OWENS CORNING
 SPECIALTY and FOAM PRODUCTS
 170 South Ave., P.O. Box 455
 Tallmadge, Ohio 44278
 1-800-875-1594 FAX: (330) 633-7316
 TAPER CONTROL CENTER

Project: CHESTERTON H.S.
 SWIMMING POOL
 CHESTERTON, INDIANA

Scale: 1/16" = 1'00" Drawn: T.L.I.
 Slope: VARIES Checked: R.E.G.
 Date: 12/10/98 T-21897C

Drawing number: 4 of 7

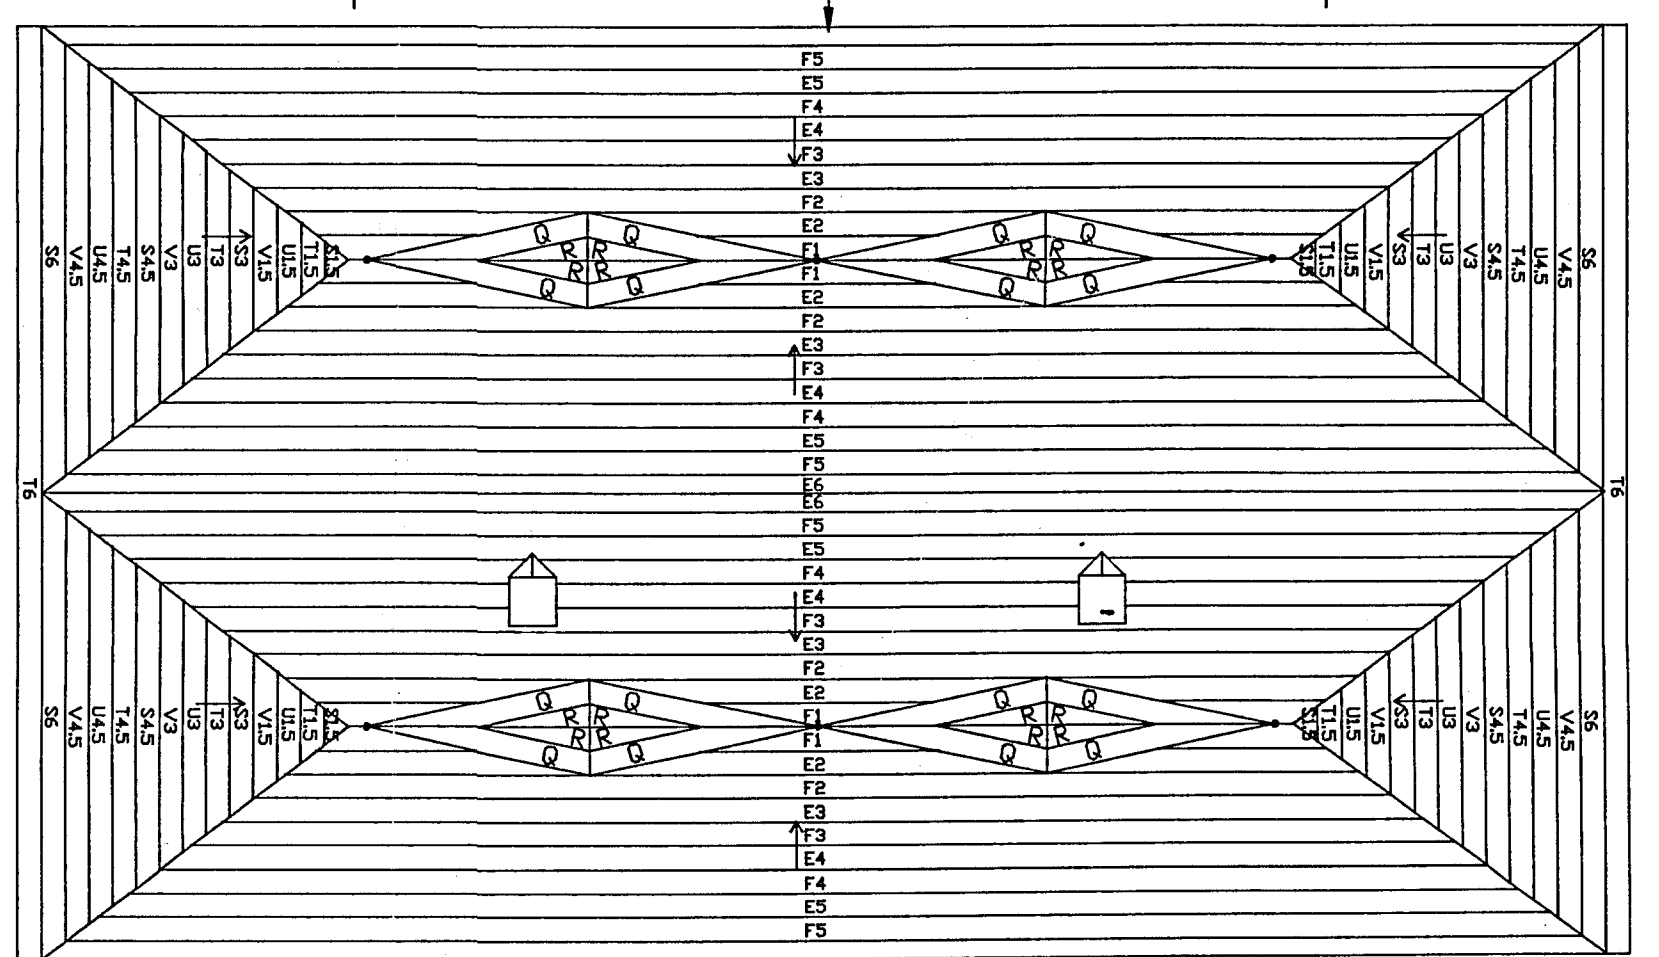
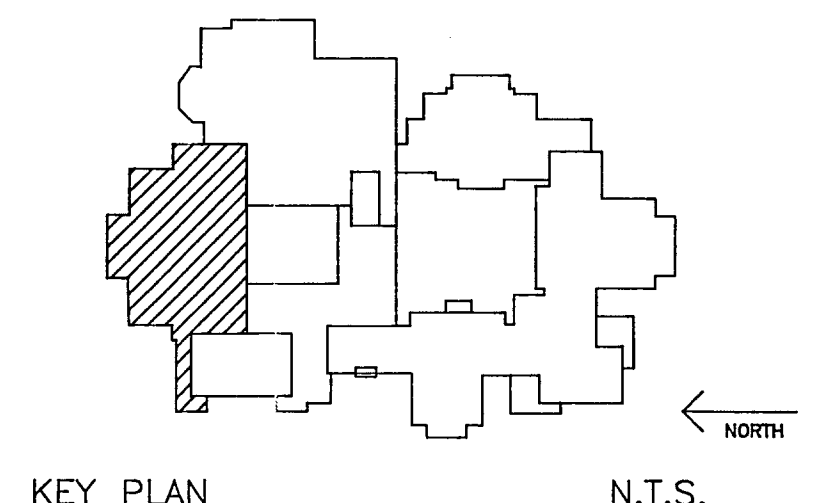
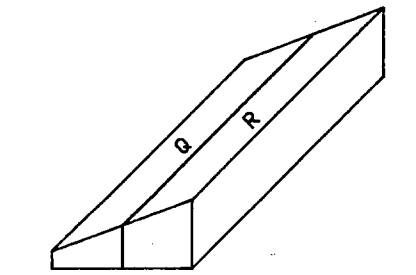
1. REVISED DRAWING FOR RELOCATION OF ROOF DRAINS PER W. R. KELSO.
2. CHANGED TAPER LAYOUT, SADDLE SLOPE THICKNESS PER FANNING & HOWEY 2/6/98
3. ADDED DRAINS & CHANGED SLOPES 4/14/98
4. CHANGED SLOPES IN VARIOUS ROOF AREAS AND MOVED DRAINS. 5/14/98
5. CHANGED 3/16" PER FT. SLOPE TO 1/4" PER FT. SLOPE DUE TO DEFLECTION IN DECK 11/18/98.

6. CHANGE MAIN ROOF BACK TO ORIGINAL DESIGN.
 12/10/98.
